February 27, 2013

RE: 2nd Revision to PCB Cleanup and Disposal Notification

Joseph A. DePaolo Middle School, 385 Pleasant Street, Southington, CT

ATTACHMENT B TYPICAL WINDOW COMPONENTS

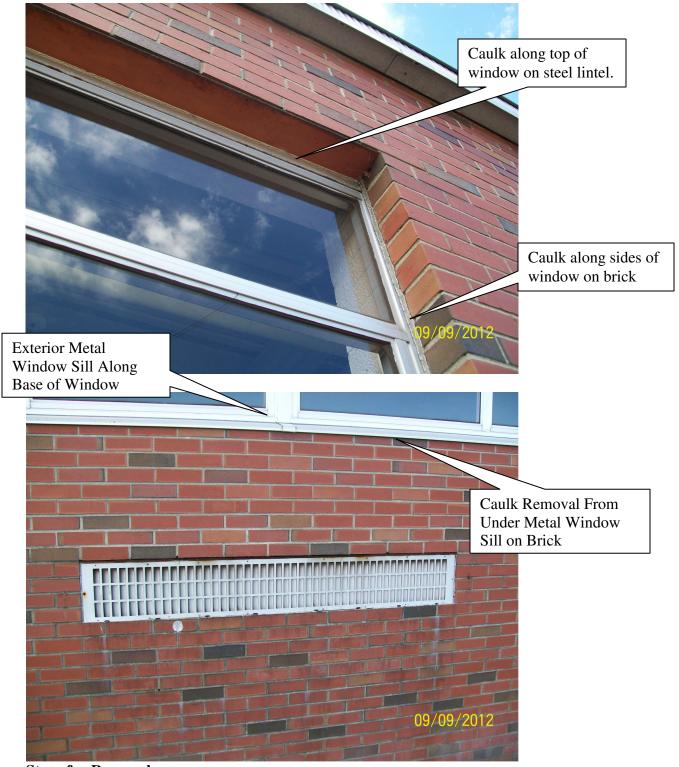
- 2. In your Feb. 18, 2013 response #21a, it is confusing. You indicate that there is a steel lintel above the windows but that there is brick on the sides and the bottom. You then say that the window unit and "metal sill" will be removed. You had previously indicated that the steel lintel above the window would be removed. Thus, could you clarify the reference to "metal sill". While I understand that you have designated the caulk associated with the windows as an Excluded PCB Product regulated for disposal under the state regulations, I thought that clarification regarding what materials are being removed is needed for plan completeness and accuracy. Please find the attached photo description.

Steps for Removal:

- 1. Remove window & metal sill along the base of the window
- 2. Remove remaining caulk from the steel lintel along the top of the window opening and from the brick on the sides and along the base of the window opening.
